**FIGURE R3.9.2-1**  
Noise Measurement Locations

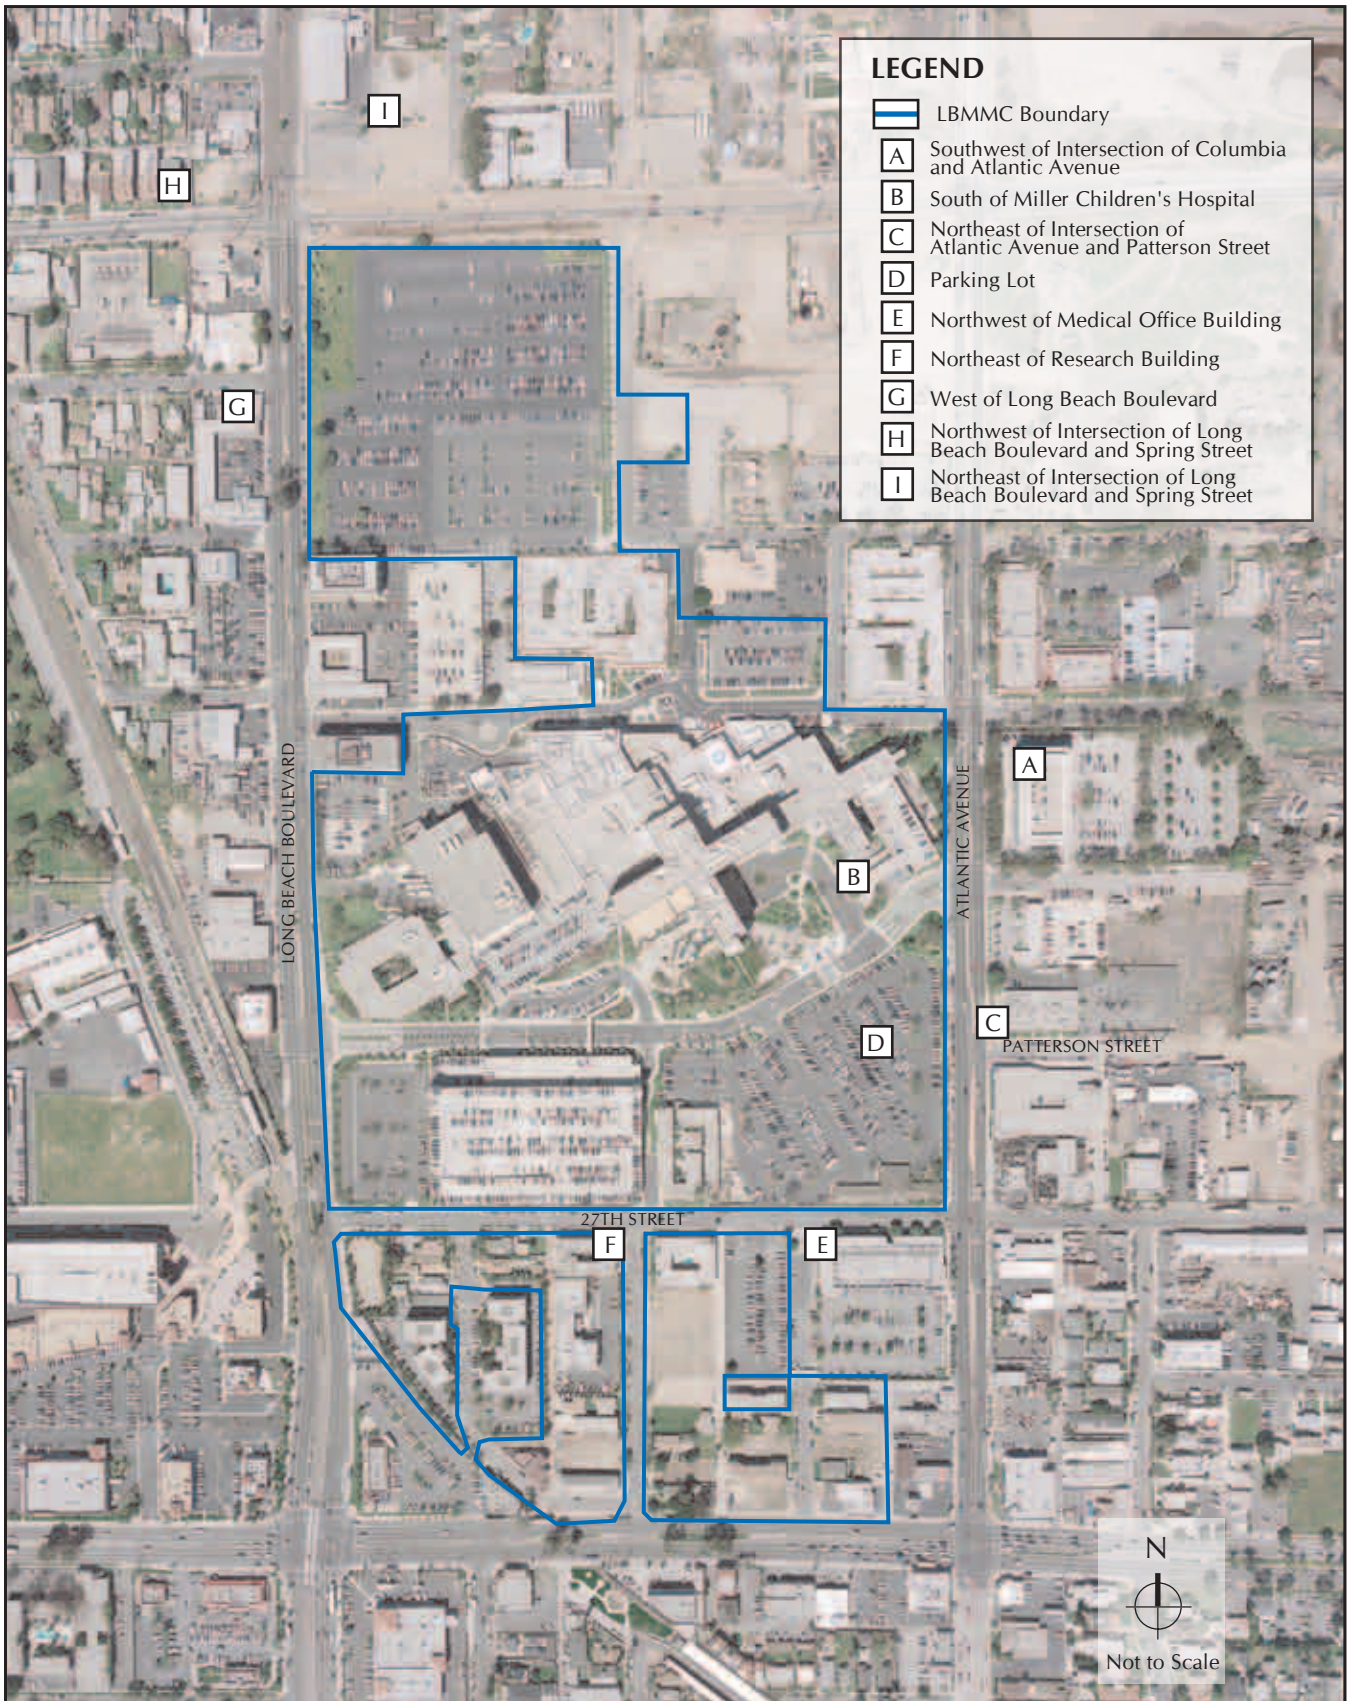
Page 3.9-9 The northeastern boundary of the Campus was revised in Figure 3.9.2-1 and replaced by Figure R3.9.2-1.

In the first sentence of the first paragraph under this heading, please replace the reference to (Figure 3.9.2-1, *Noise Measurement Locations*) with the following:

(Figure R3.9.2-1, *Noise Measurement Locations*)

**FIGURE R3.10.2-1**  
Public Services Near the Proposed Project

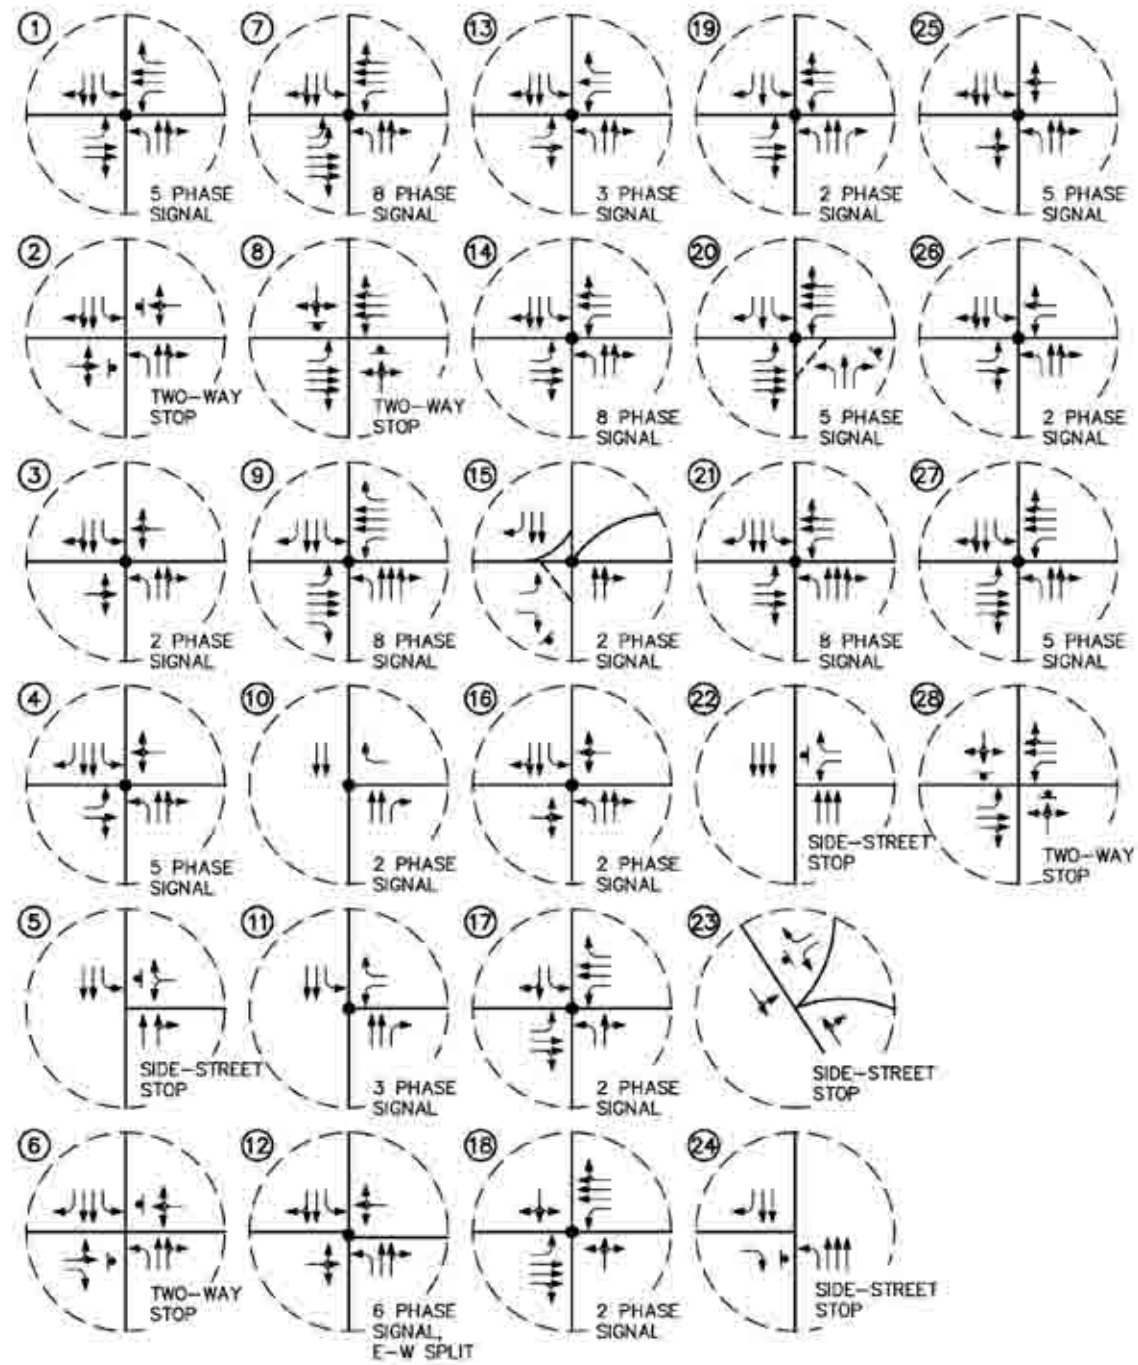
Page 3.10-3 The northeastern boundary of the Campus was revised in Figure 3.10.2-1 and replaced by Figure R3.10.2-1.

In the first sentence of the second paragraph under this heading, please replace the reference to (Figure 3.10.2-1, *Public Services near the Proposed Project*) with the following:

(Figure R3.10.2-1, *Public Services near the Proposed Project*)

**FIGURE R3.11.2-1**  
Existing Roadway Conditions and Intersection Controls

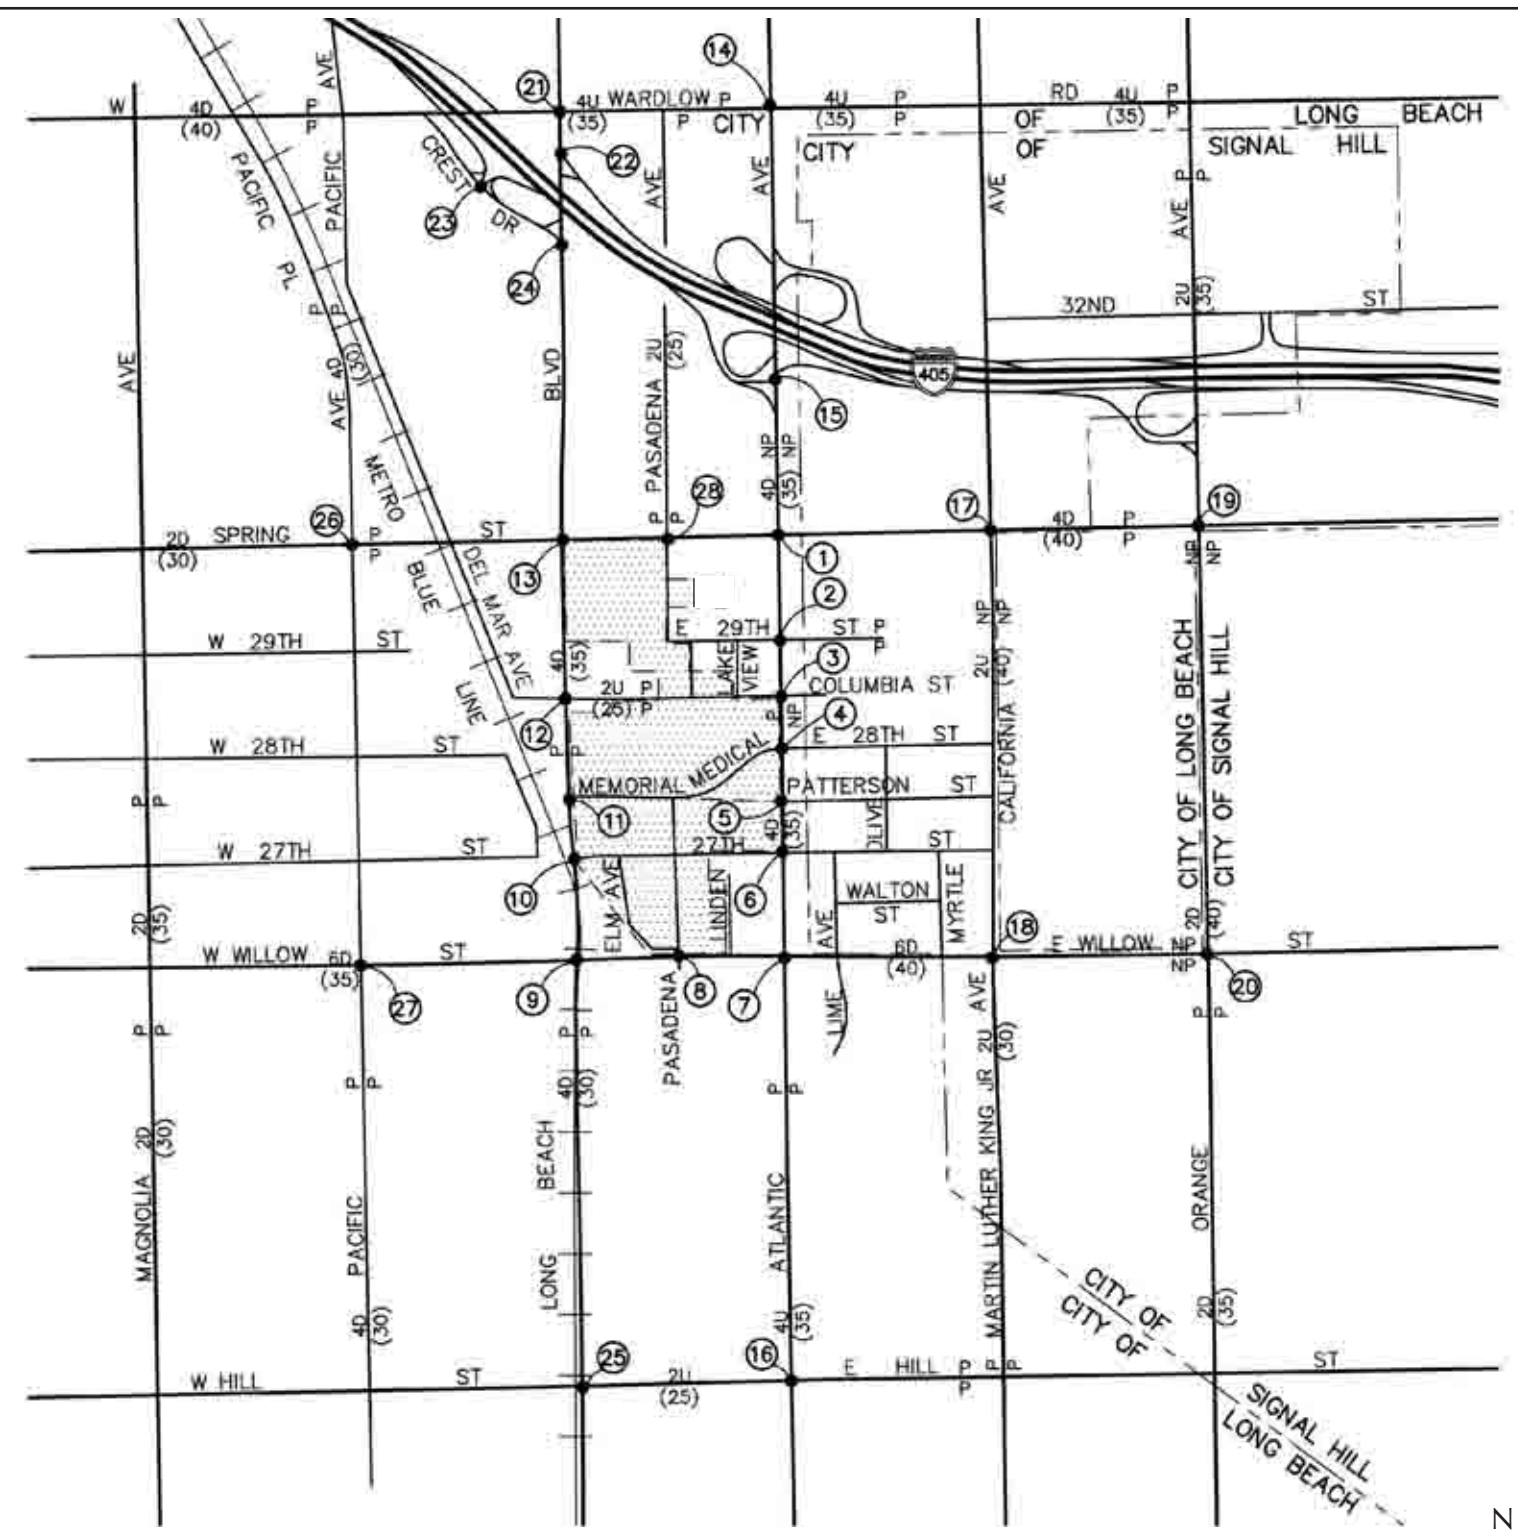
Page 3.11-3 The northeastern boundary of the Campus was revised in Figure 3.11.2-1 and replaced by Figure R3.11.2-1.

In the last sentence of the second paragraph under this heading, please replace the reference to (Figure 3.11.2-1, *Existing Roadway Conditions and Intersection Controls*) with the following:

(Figure R3.11.2-1, *Existing Roadway Conditions and Intersection Controls*)

**FIGURE R3.11.2-2a**  
Existing A.M. Peak-Hour Traffic Volumes

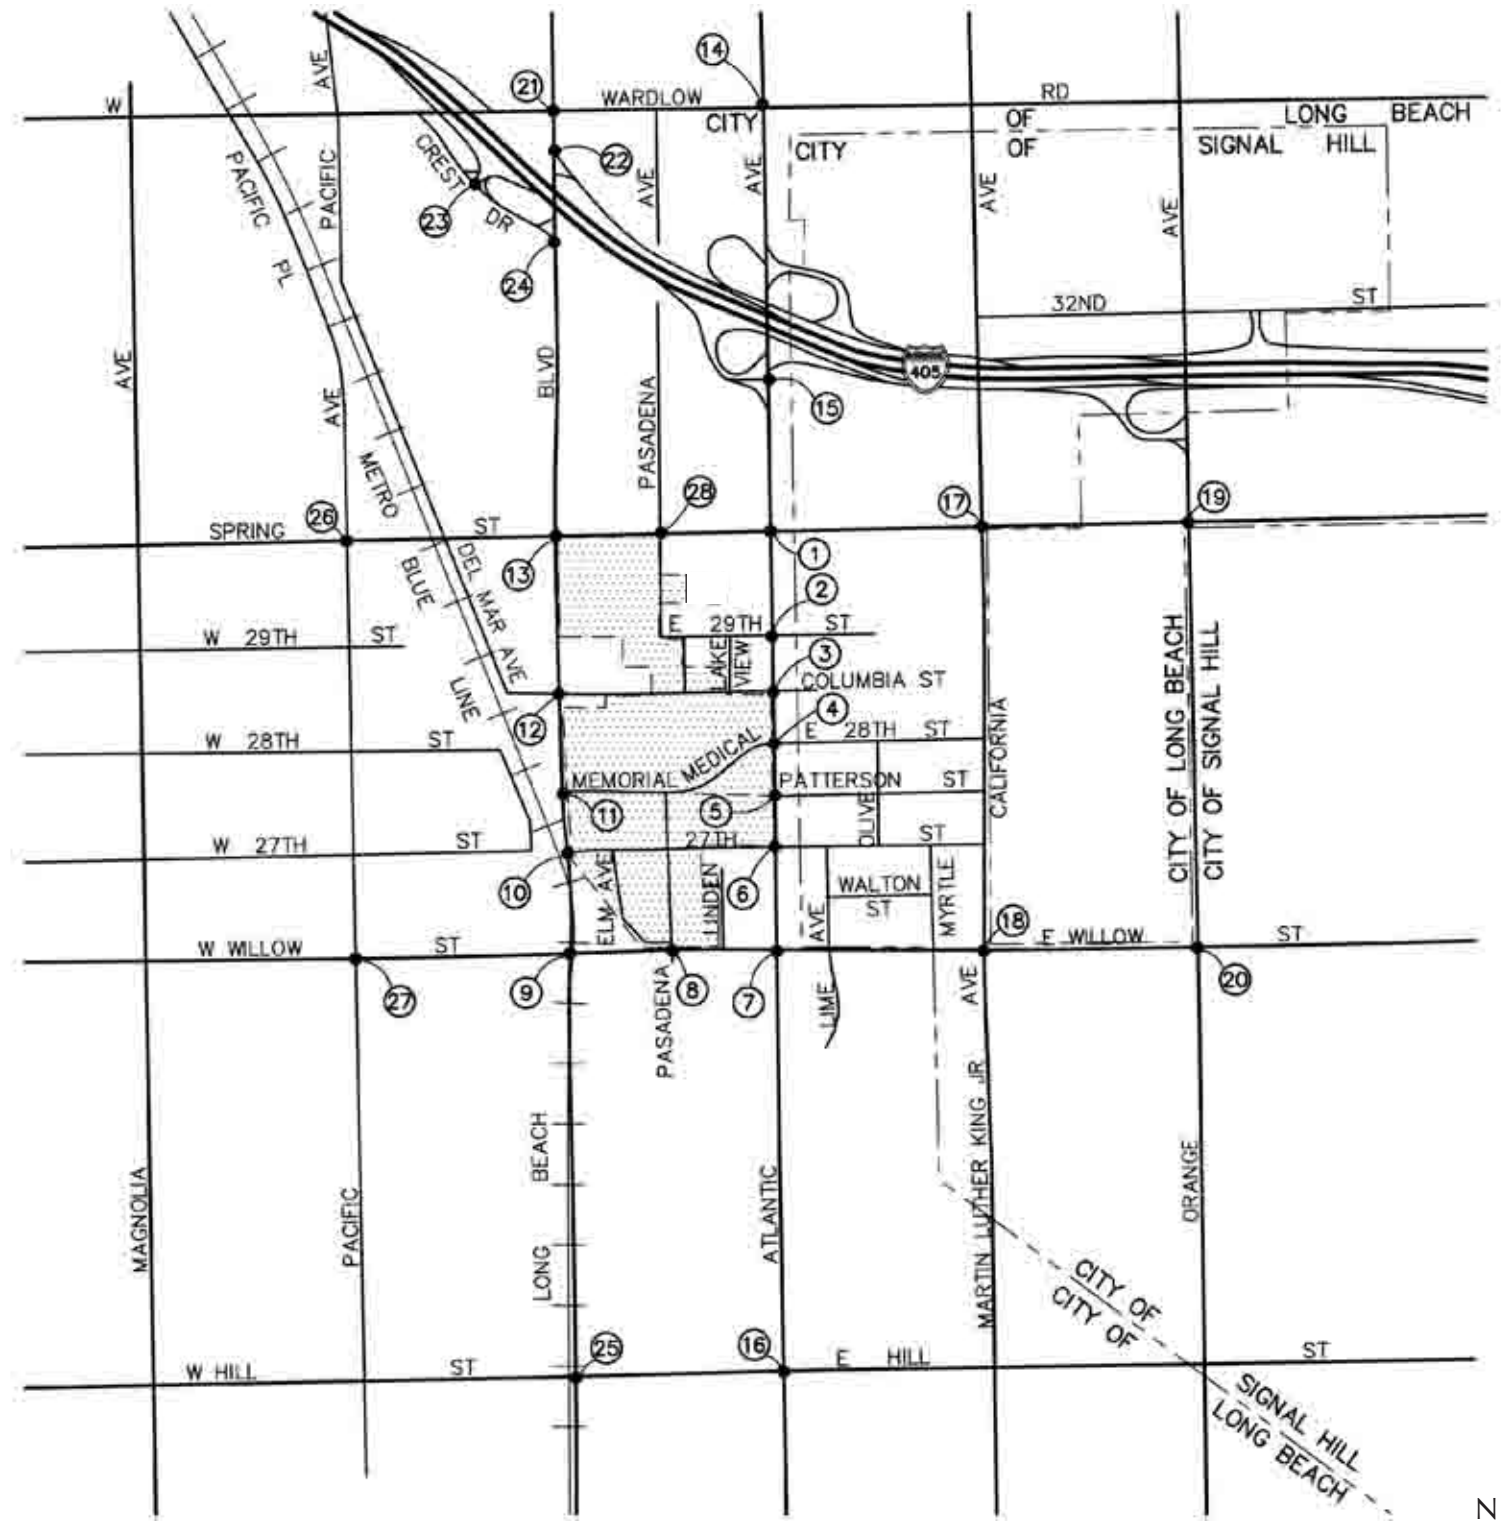
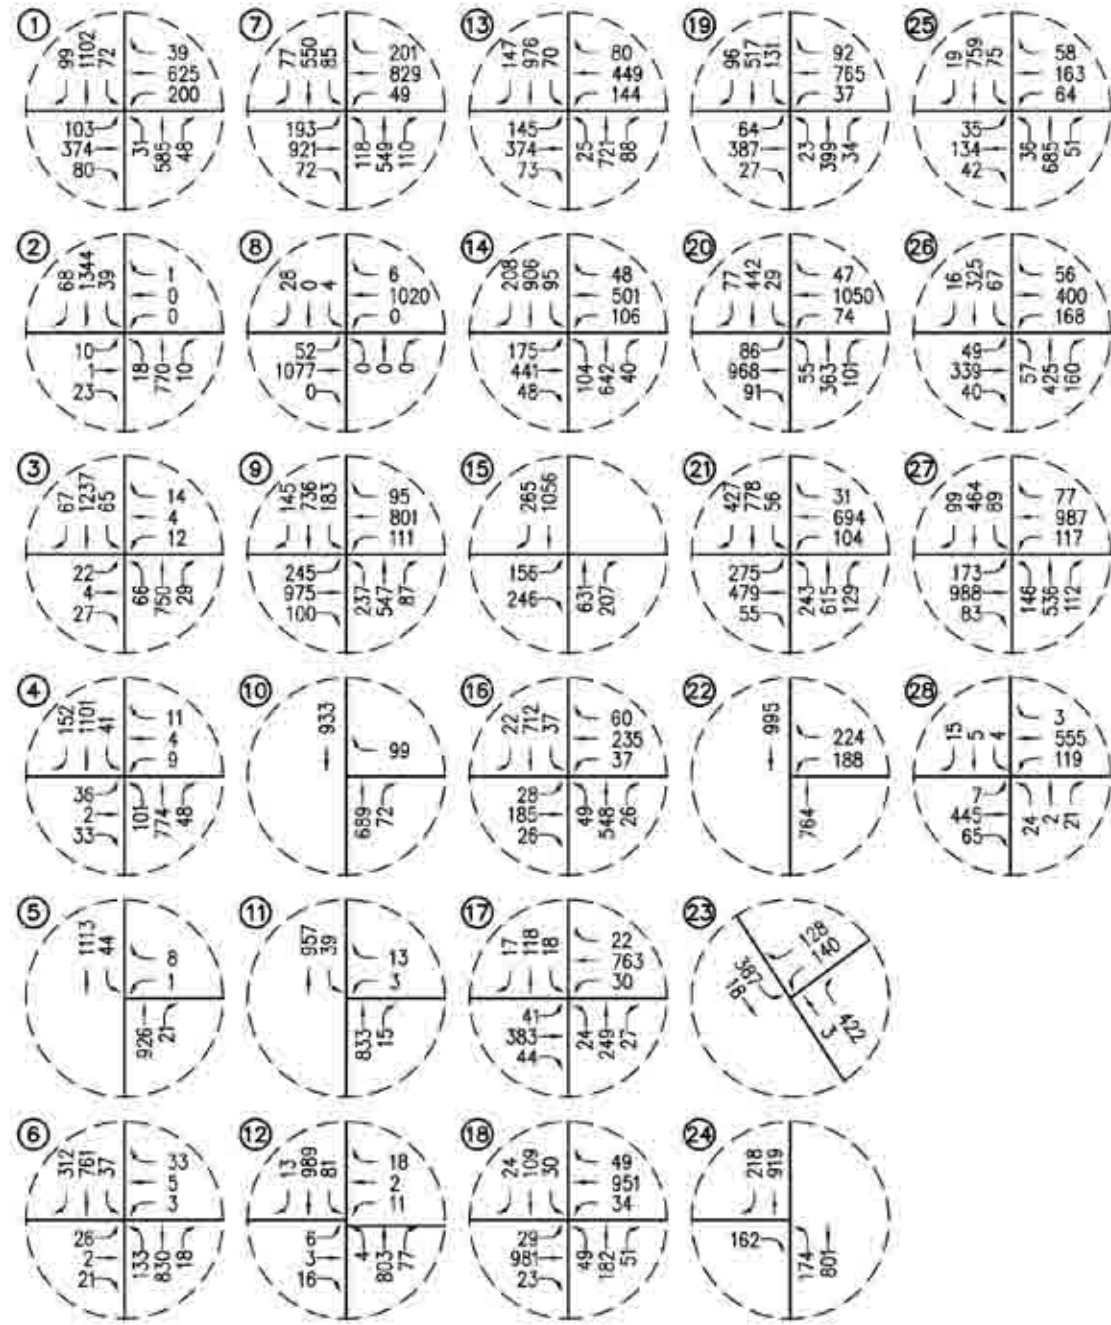
Page 3.11-4 The northeastern boundary of the Campus was revised in Figure 3.11.2-2A and replaced by Figure R3.11.2-2A.

In the last sentence of the second paragraph under this heading, please replace the reference to (Figure 3.11.2-2A, *Existing A.M. Peak-Hour Traffic Volumes*) with the following:

(Figure R3.11.2-2A, *Existing A.M. Peak-Hour Traffic Volumes*)
